**RESPONSE TO THE NOVEMBER 24, 2011 INFORMATION REQUESTS FROM THE
MACKENZIE VALLEY ENVIRONMENTAL IMPACT REVIEW BOARD
FOR THE THOR LAKE RARE EARTH ELEMENT PROJECT
DEVELOPER'S ASSESSMENT REPORT**

**Submitted To:
MACKENZIE VALLEY ENVIRONMENTAL IMPACT REVIEW BOARD**

December 2011

CLIENT		THOR LAKE PROJECT			
AVALON RARE METALS INC.		Tailings Management Facility Feasibility Design Summary General Arrangement			
PROJECT NO. V15101007.006.014	DWN JAB	CKD RH	REV 1	Figure 4.7-6	
OFFICE VANC	DATE April 28, 2011

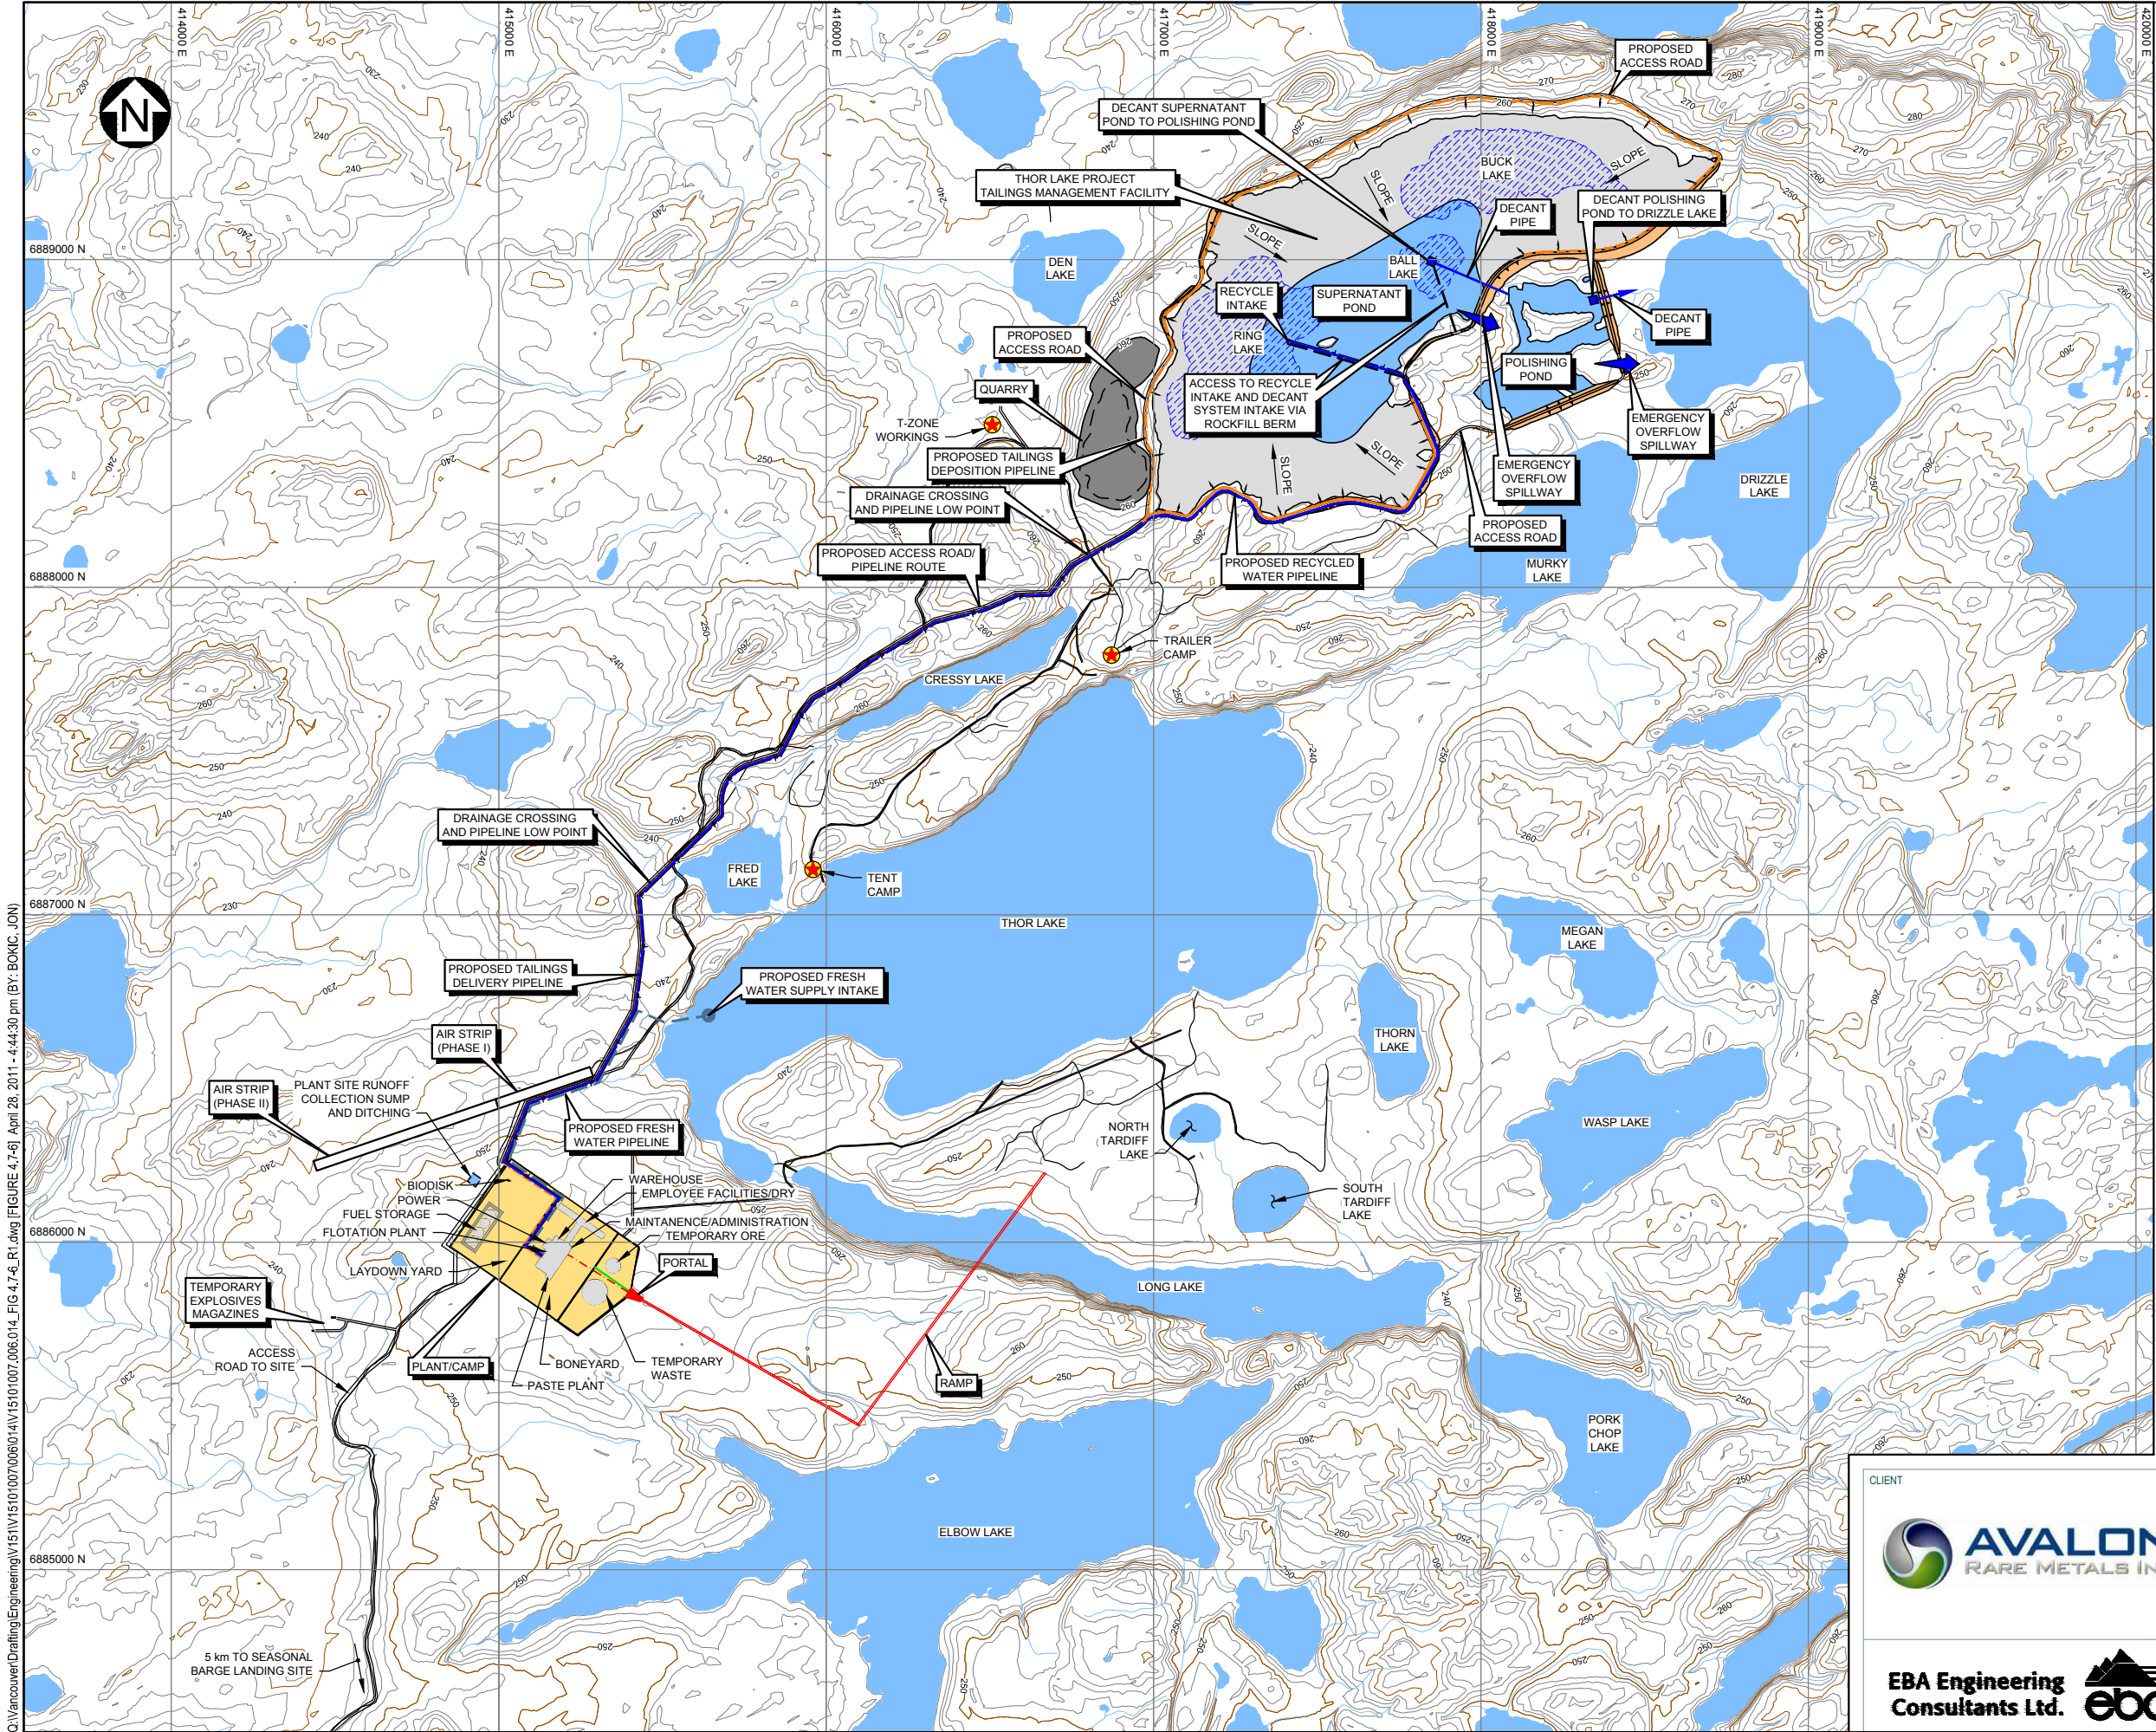
The DAR does not include any discussion of the potential impacts of the tailings delivery pipelines freezing, leaking, or rupturing. Freezing or failure of the flotation plant tailings delivery pipeline could cause uncontrolled slurry loss anywhere along the pipeline route at up to nearly 53 m3 per hour, including several locations uphill from and close to Fred, Cressy, and Thor lakes.

Please describe the engineering safety features and operational controls designed to prevent or minimize the consequences of the tailings delivery pipeline freezing or failing. Please also describe the foreseeable potential impacts of a pipeline failure on the streams, wetlands, or surface water bodies along the routes of both the flotation plant and the hydrometallurgical plant tailings delivery pipelines.

Figure 4.7-6 of the DAR (re-presented with this response) illustrates the general layout of the tailings delivery pipeline system from the perimeter of the Nechalacho Flotation Plant site to the most westerly portion of the TMF and the two branches of the pipeline around the north and south sides of the TMF. The length of the pipeline between the plant site and the TMF is approximately 3.2 km. This pipeline comes within approximately 50 m of the west side of Fred Lake, and about 100 m from the northwest side of Cressy Lake en route to the TMF.

As discussed earlier in this response, the tailings delivery pipeline will be designed, operated and monitored to minimize the risks of pipeline failure. The plan to locate the tailings pipeline on the west/northwest side of the access road to the TMF will assist in ensuring that if there was a tailings delivery pipeline failure, the presence of the road would serve as a barrier to prevent the possible migration of any spilled tailings towards the nearby lakes, including Fred Lake, Cressy Lake and Thor Lake.

The presence of the access road would also help to contain any spilled tailings resulting from a tailings delivery pipeline failure to the immediate vicinity of the west/northwest side of the road.

The vegetation cover along the 3.2 km of tailings delivery pipeline extending from the Flotation Plant to the TMF is mainly dominated by moderately well-drained Spruce Upland (BF – *Black spruce – feathermoss - crowberry upland forest* and WA – *White spruce – green alder – prickly rose forest*), and Bedrock-Lichen ((LW – *Lichen-bearberry woodland*) in the higher areas, and by relatively poorly-drained Shrub Fen (SS – *Scrub birch – sweet gale – bog rosemary fen*) in lower areas.

As a result, any spilled tailings caused by a potential tailings delivery pipeline failure would be expected to be deposited alongside the access road within these forested ecosystem types in the immediate vicinity of the breach.

CLIENT		THOR LAKE PROJECT			
AVALON RARE METALS INC.		Tailings Management Facility Feasibility Design Summary Final (Phase 2) Tailings Facility Plan			
PROJECT NO. V15101007.006.014	DWN JAB	CKD RH	REV 1	Figure 4.7-8	
OFFICE VANC	DATE April 28, 2011				
EBA Engineering Consultants Ltd.		eba

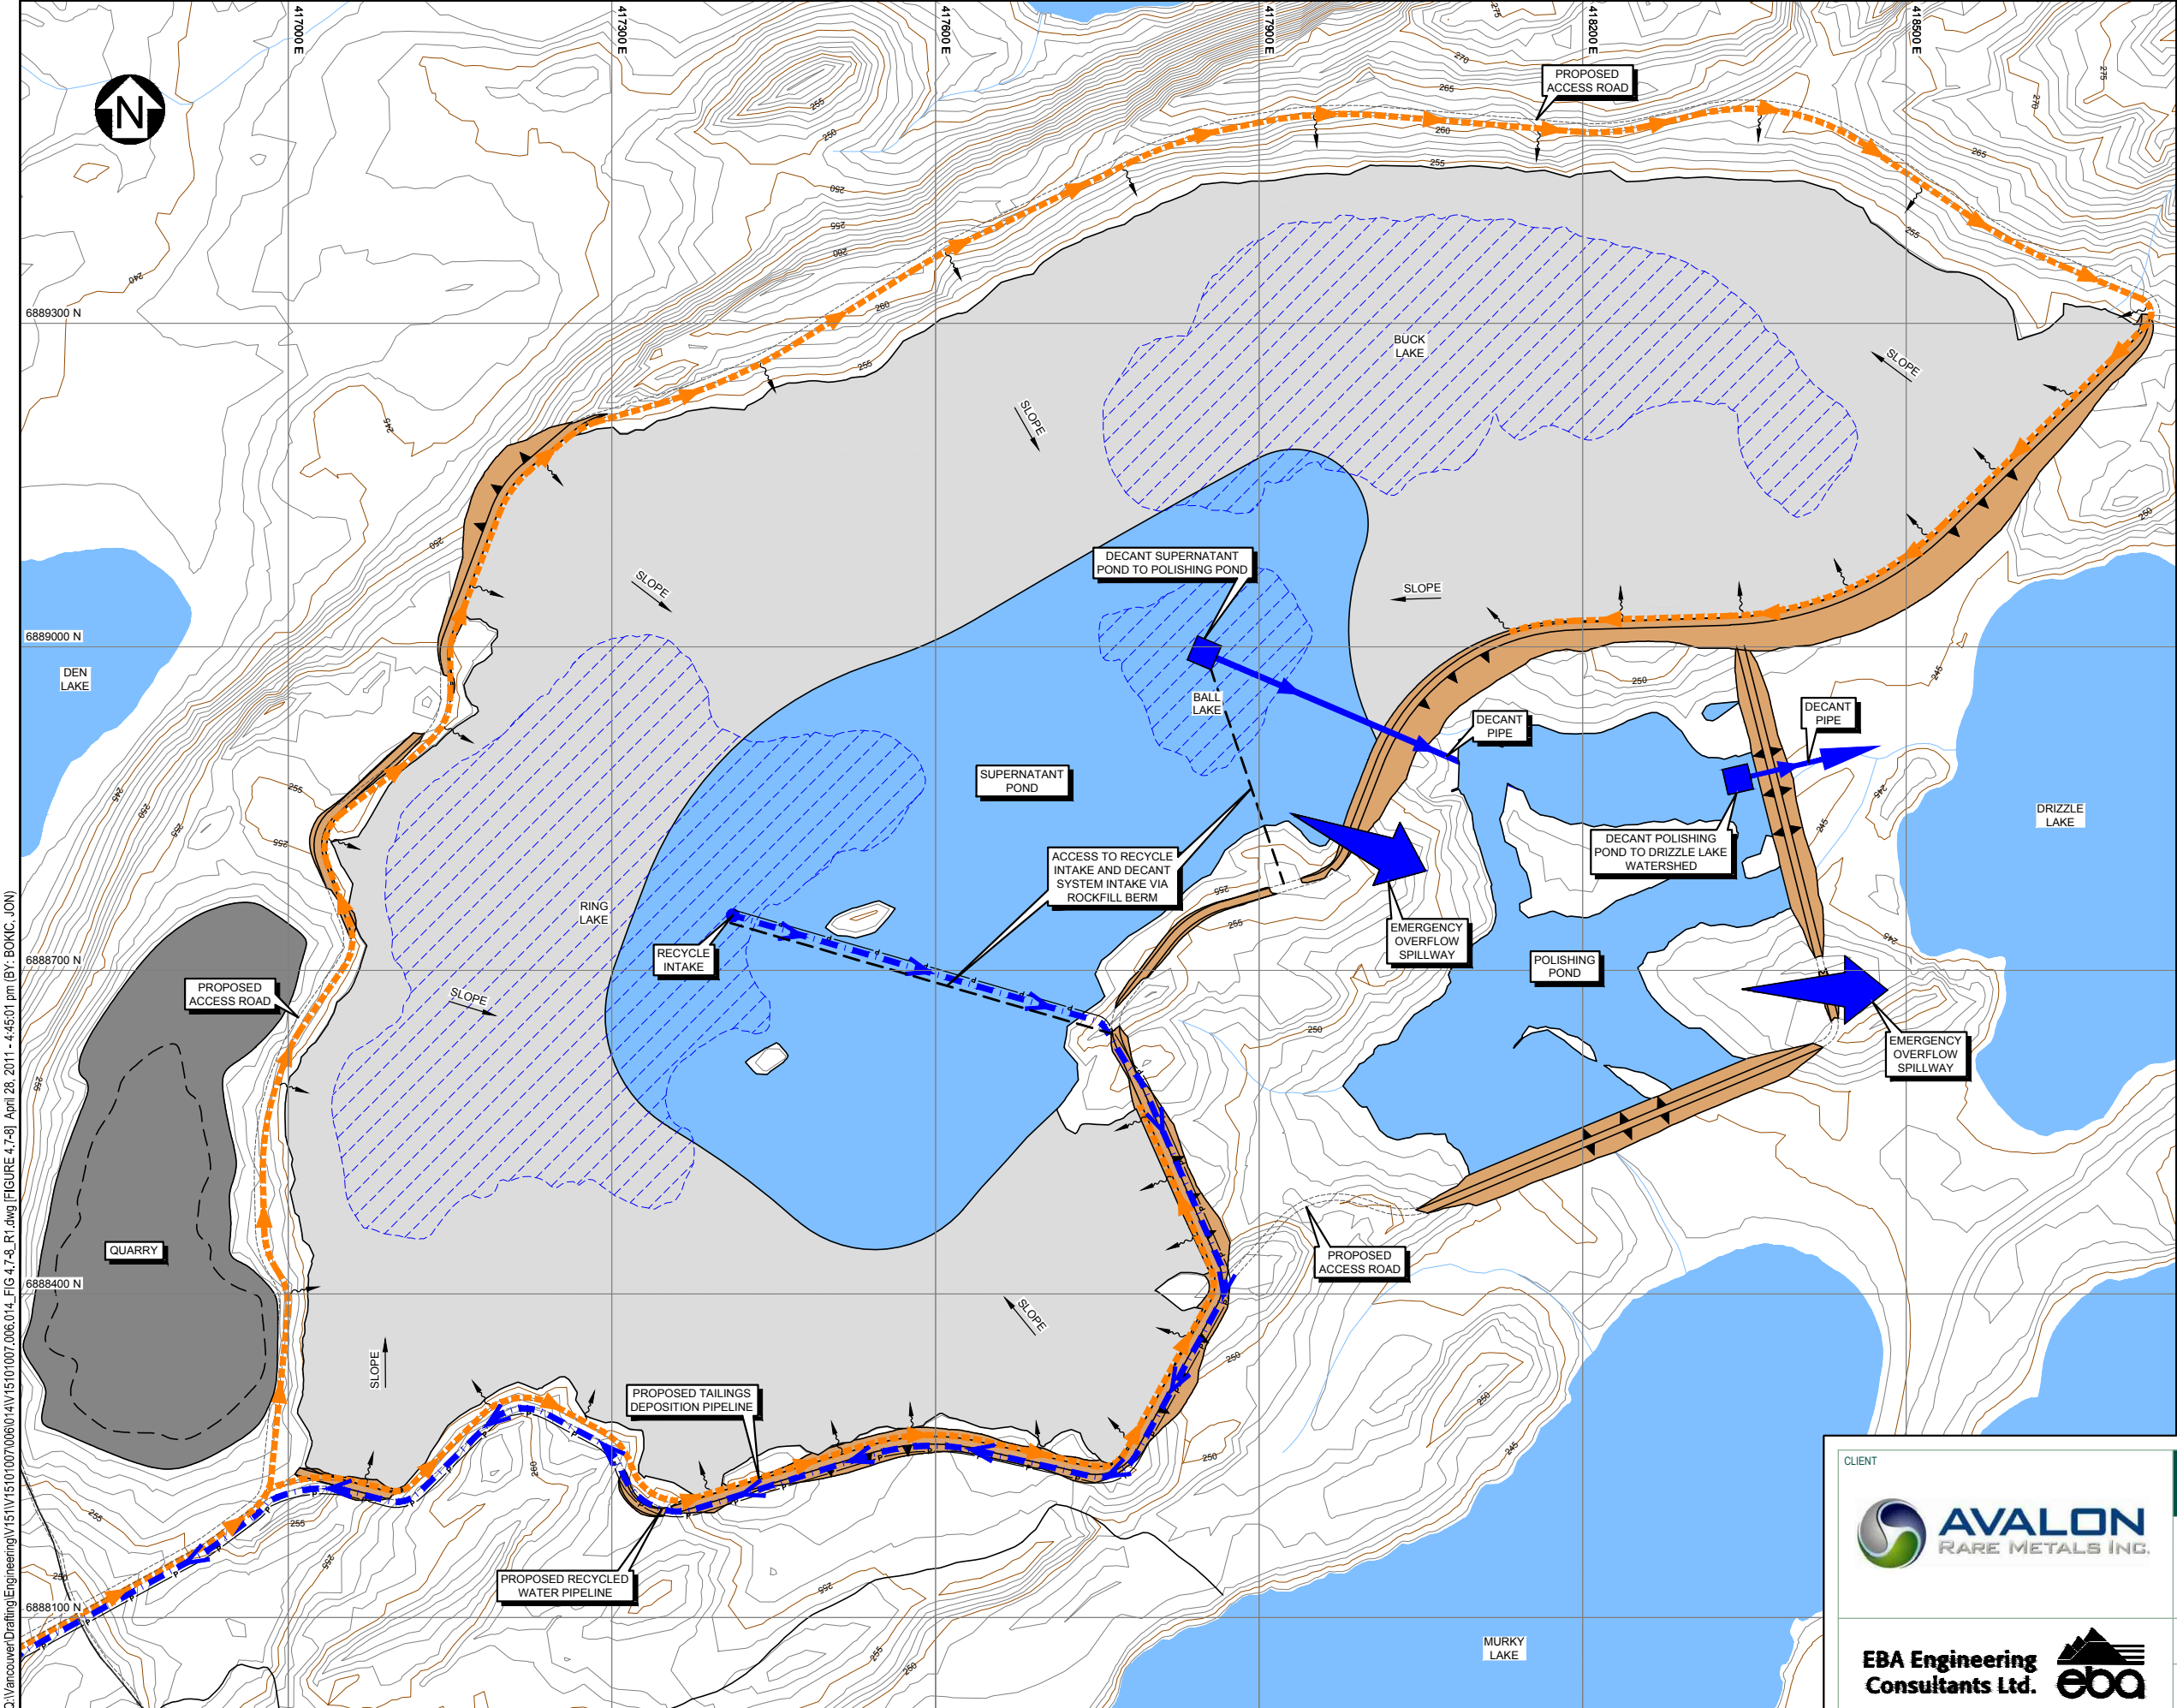
The DAR very briefly discusses the potential impacts of a dike failure on the discharge side of the tailings management facility (p.890), and does not consider the impacts of a failure of the dike on the upstream side at all.

Please describe the potential for and quantify the potential impacts of a failure of the dike along the upstream (northwest) side of the TMF. The discussion should include the volume of a potential breach, the material characteristics of the outflow, and the path and destination of the lost material.

The small embankment (dike) to be located on the northwest side of the TMF facility will be founded on an area of exposed, high quality bedrock as verified by recent geotechnical site investigations. This area is of naturally higher elevation than much of the southeastern portion of the TMF, with a maximum embankment height of less than 6 m. Tailings will be deposited in the area upstream of this embankment to direct the water towards the southeast side of the facility, thus maintaining relatively dry, stable beaches in the area with no free standing water directly upstream of the embankment.

Embankment failures are typically the result of either overtopping due to loss of freeboard (i.e. localized embankment settlement), water located upstream of the embankment (i.e. causing internal erosion), or unsuitable foundation conditions leading to lack of physical stability. None of these conditions are present at this location and subsequently there is very low potential for failure of the embankment at the northwest side of the TMF.

In the unforeseeable event of a failure at this location, it is anticipated that there would be very little migration of tailings or water to the downstream given the consolidated and relatively dry state of the tailings deposit in this area. Clean-up would be minimal and could be accomplished in a very short period of time.

Nevertheless, for the sake of assessing possible environmental consequences of such an unlikely event occurring, it has been assumed that a limited volume of relatively dry tailings, in the order of 100 - 300 m³ could conceivably flow out of a hypothetical north tailings embankment breach into the immediate surrounding vegetated terrain.
